**RE: Response to Comments**

**The Aurora Highlands Lennar Phase 1 – Site Plan – First Review**

**Application Number: DA-2062-61**

**Case Numbers: 2024-4018-00, 2024-3038-00**

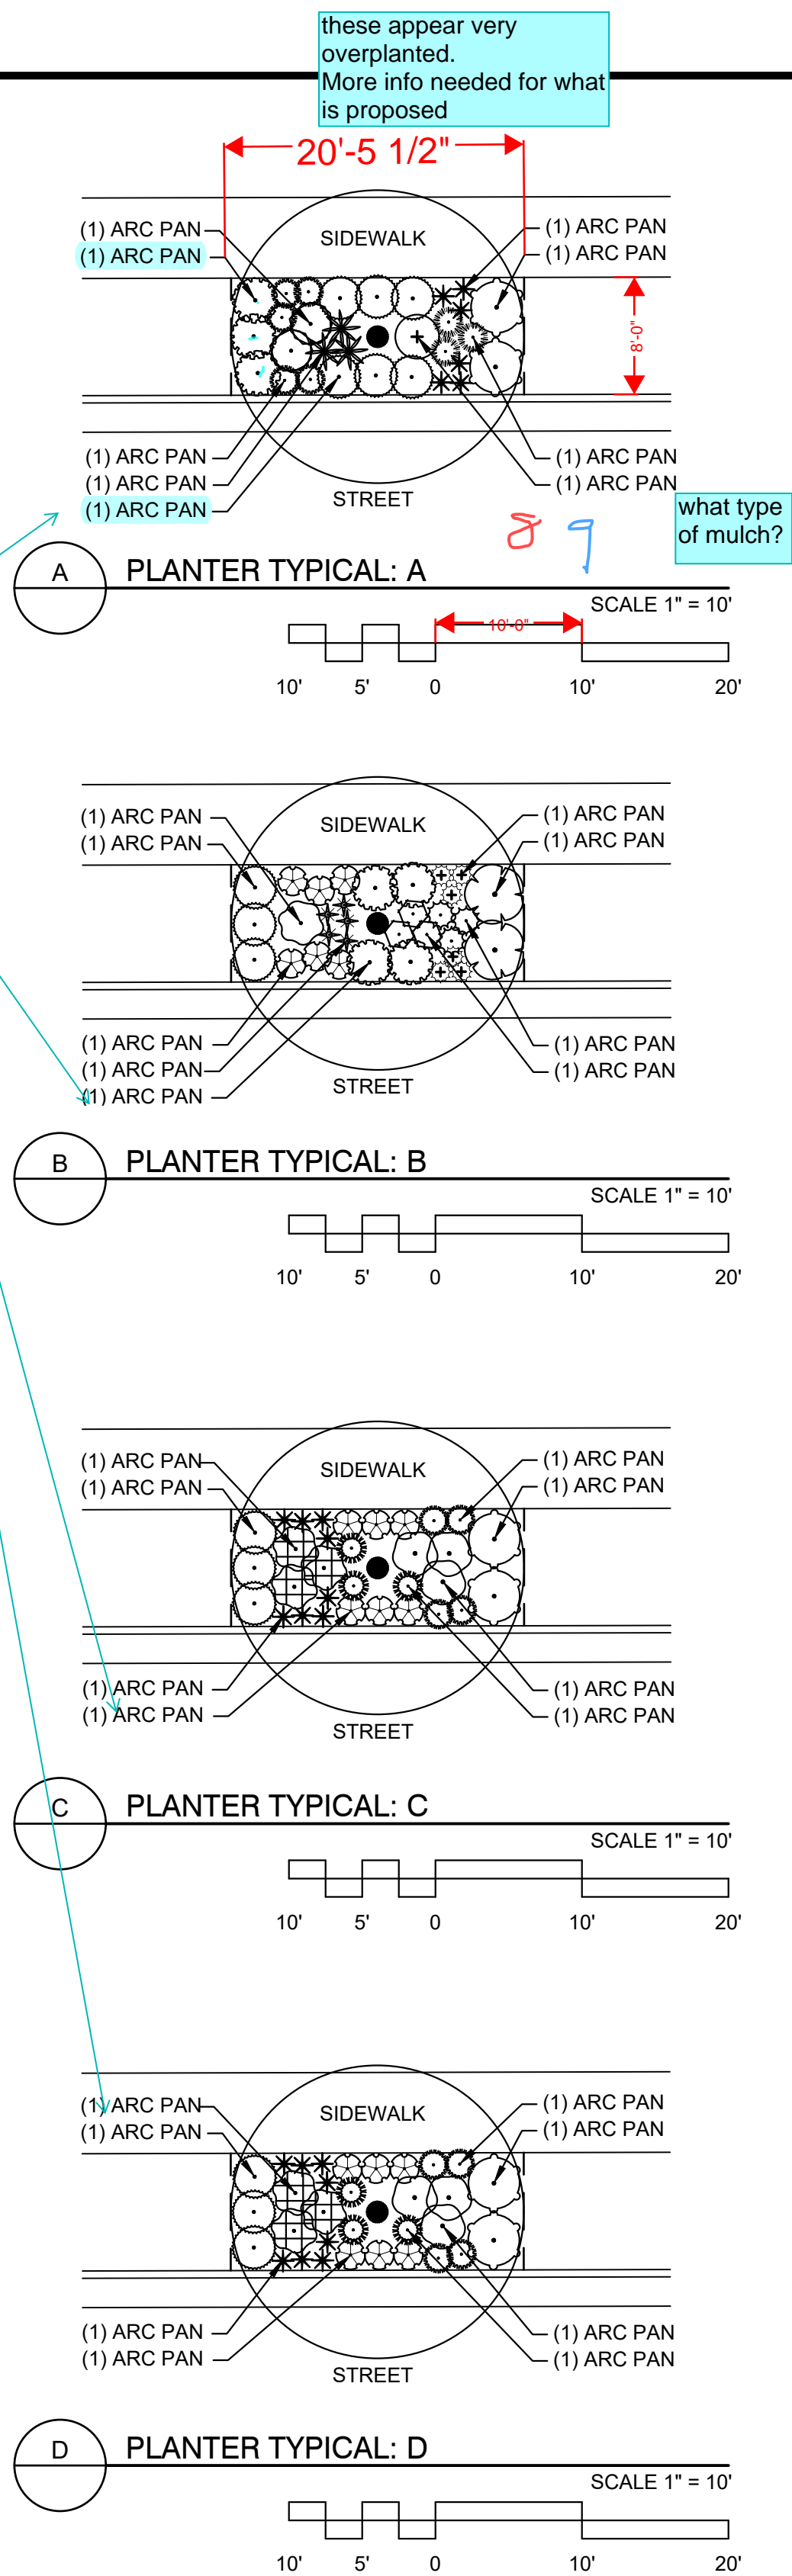
INO ROU	8,485 SF	be more INOR specific	ORGANIC MULCH	INORGANIC MULCH
--	---------	----------	--------------------------	---------------	-----------------

Add the size at installation  
ie. caliper, gallons

***Response: Size of plant material at the time of installation is now specified in the plant schedule.***

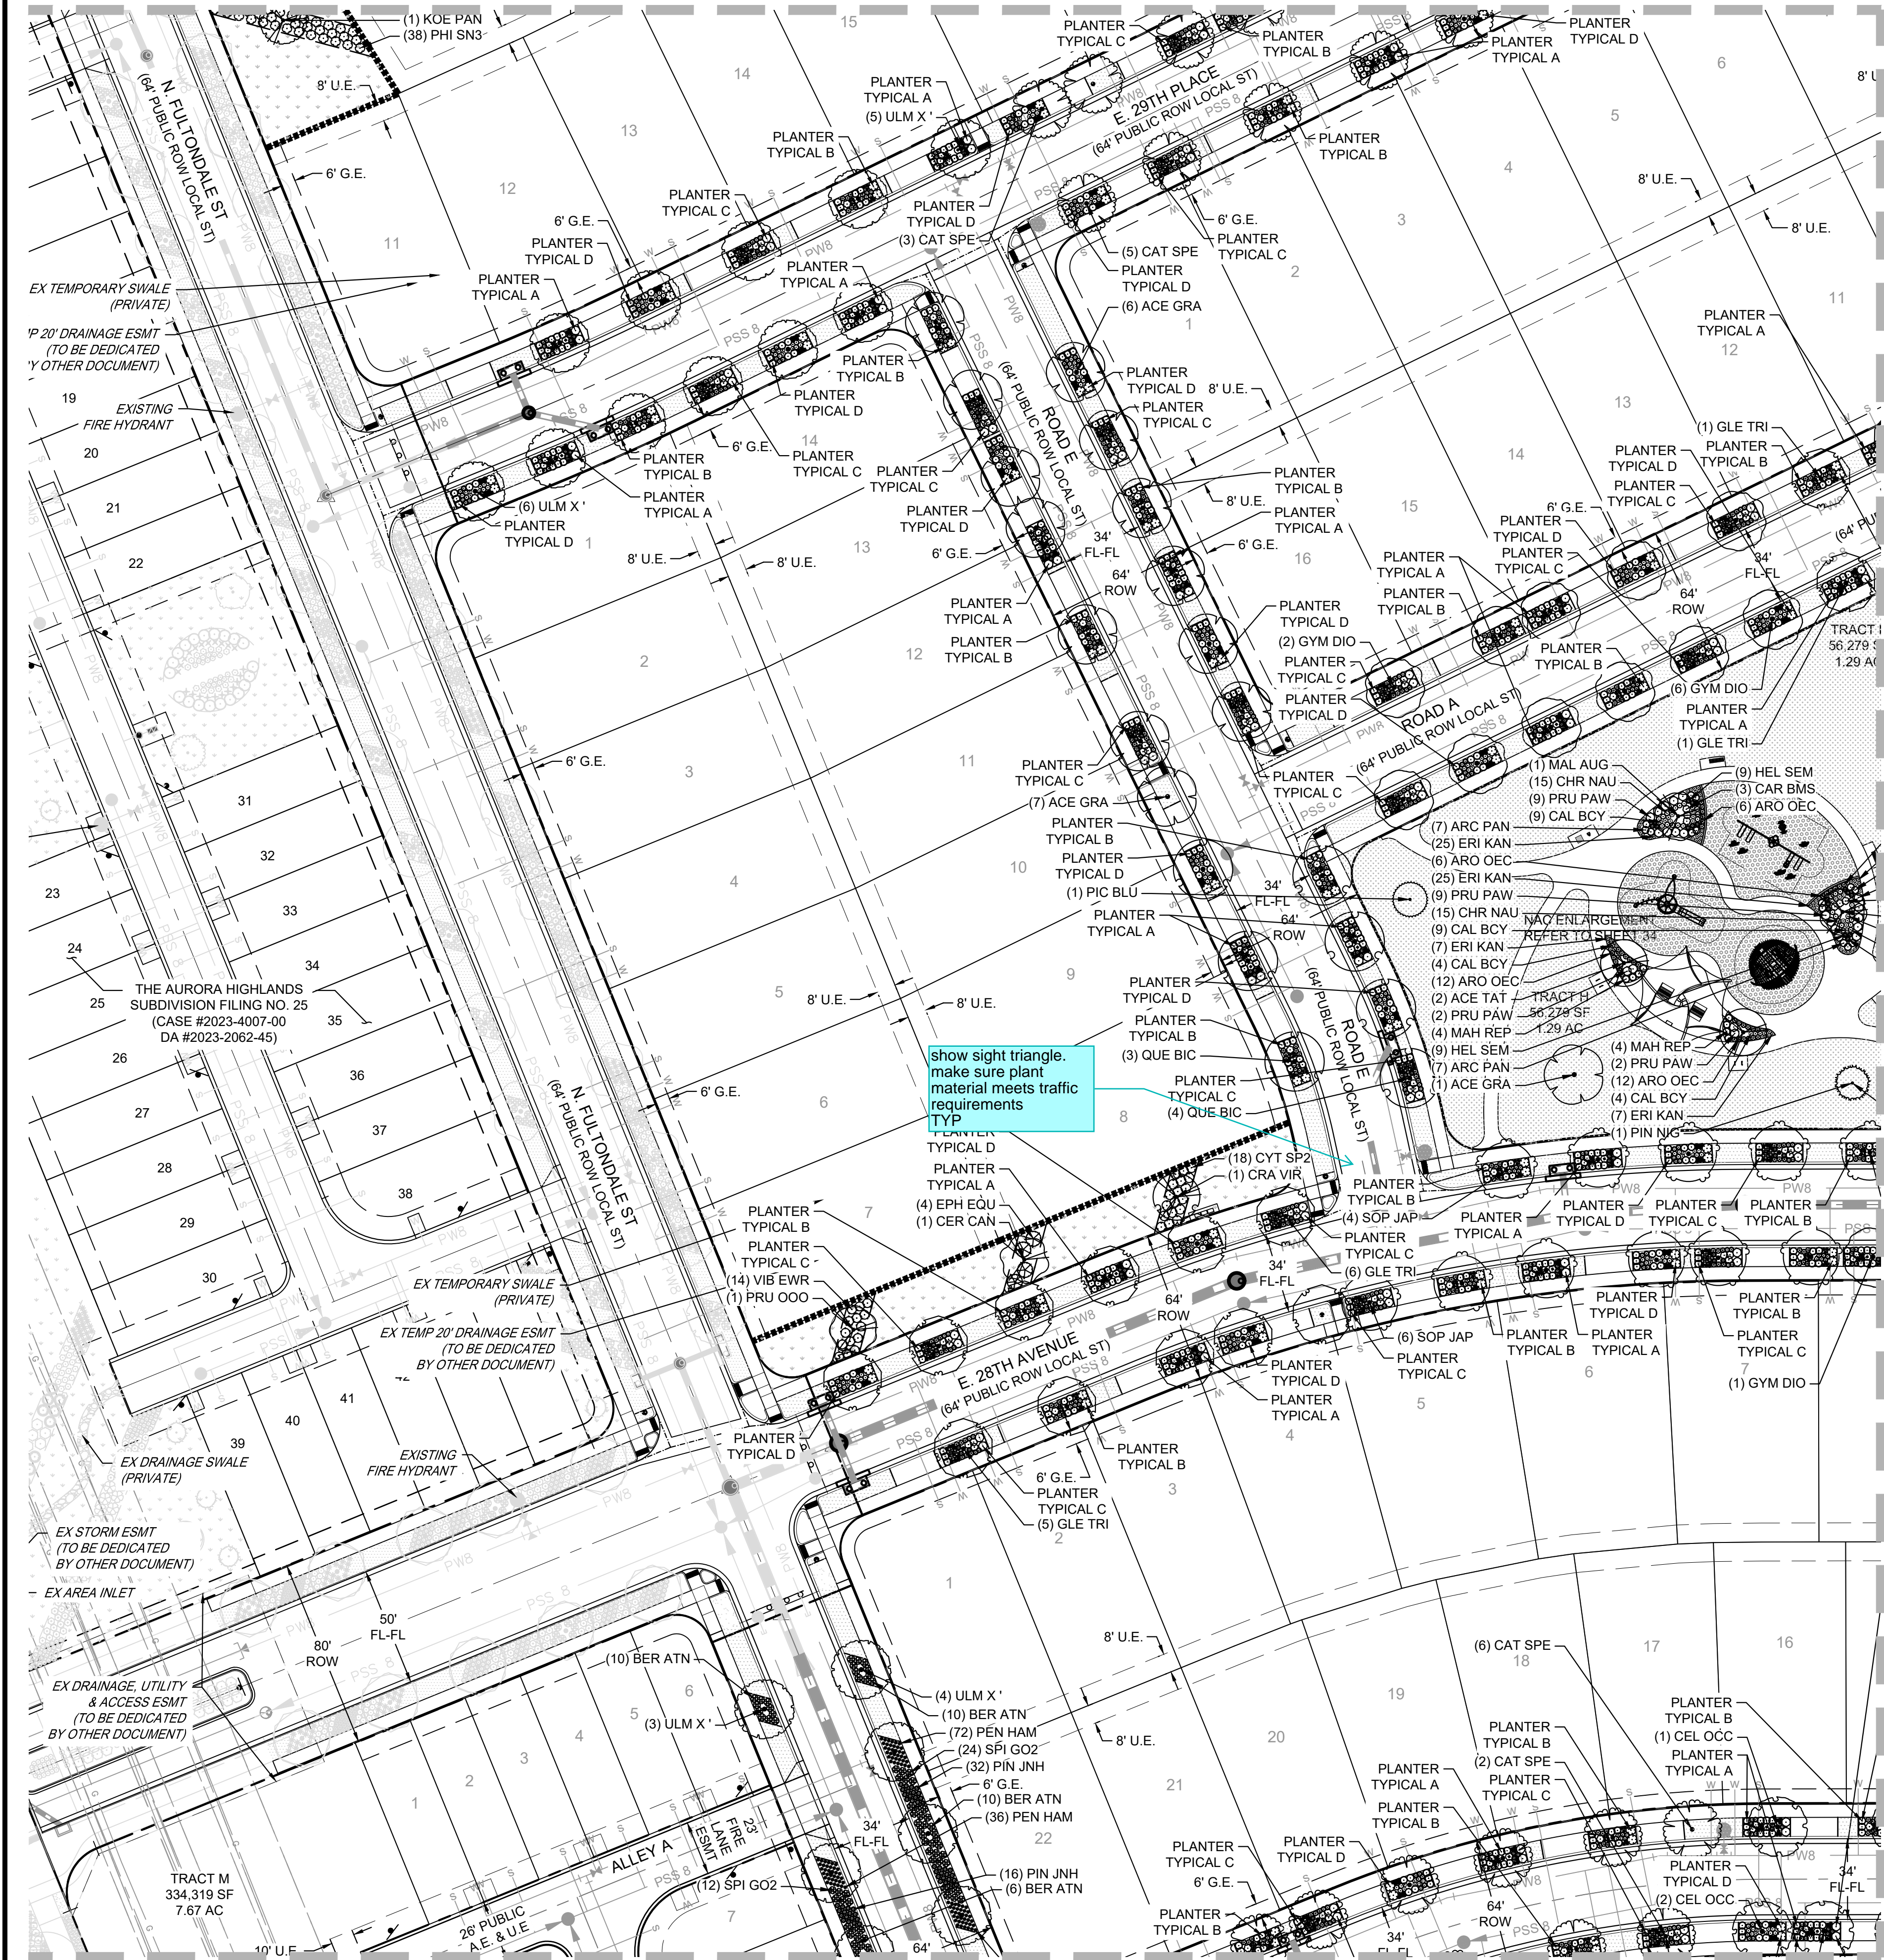
remove seed from  
landscape beds.

fix overwrites  
TYP

add this symbol to the  
legend

***Response: Pothole information has been removed. Overwrites are eliminated.***
